Access Compliance Report

Intersection ID: 20485	Main Street: FAIRVIEW_RD	Cross Street: ASHLEY_PARK_LN	Location: SE
ADA ID: 4725E5DE734B	Ramp Type: PerpDiag	Initial Pass/Fail: Fail	Overall Compliance: No
			Severity Score: 13.75

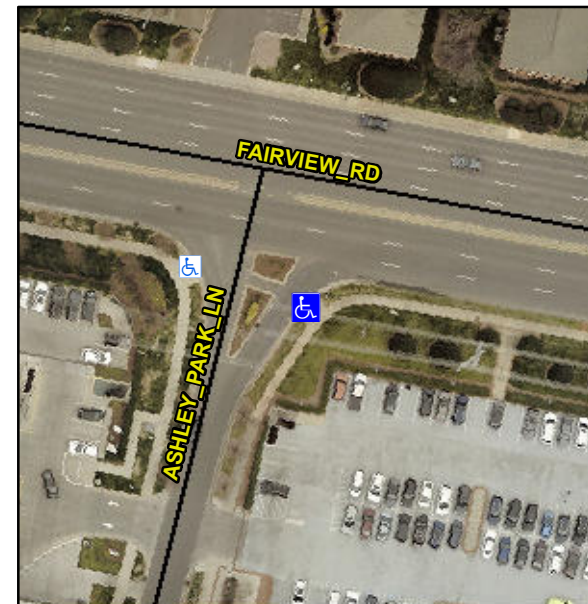
R304.2.2, R304.5.3

Compliance	Description	Data	Compliance	Description	Data
N/A	Ramp Length (in)	89.0	No	Ramp Slope (%)	10.8
Yes	Ramp Width (in)	48.0	No	Ramp XSlope (%)	2.7
N/A	Flare Type LT	N/A	N/A	Flare Type RT	N/A
N/A	Flare Slope LT (%)	N/A	N/A	Flare Slope RT (%)	N/A
N/A	Flare Traversable LT?	N/A	N/A	Flare Traversable RT?	N/A
N/A	Landing Length (in)	N/A	N/A	DWS Provided?	N/A
N/A	Landing Width (in)	N/A	N/A	DWS Contrast?	N/A
N/A	Landing Slope (%)	N/A	N/A	DWS Length (in)	N/A
N/A	Landing X Slope (%)	N/A	N/A	DWS Full Width?	N/A
N/A	Landing Curb? (Y/N)	N/A	N/A	DWS Offset (in)	N/A
N/A	Shared Landing?	N/A			
N/A	Gutter Ponding?	N/A	N/A	Gutter Slope (%)	N/A
N/A	Gutter Lip Ht (in)	N/A	N/A	Gutter X Slope (%)	N/A
N/A	Painted X Walk1?	No	N/A	Painted X Walk2?	No
	X Walk 1 Direction	To NE		X Walk 2 Direction	To NW
N/A	X Walk 1 Width (in)	N/A	N/A	X Walk 2 Width (in)	N/A
	X Walk 1 Slope (%)	4.0		X Walk 2 Slope (%)	2.8
	X Walk 1 X Slope (%)	1.2		X Walk 2 X Slope (%)	2.1

Remove & Replace Curb Ramp With Two New Directional Ramps or Equivalent.
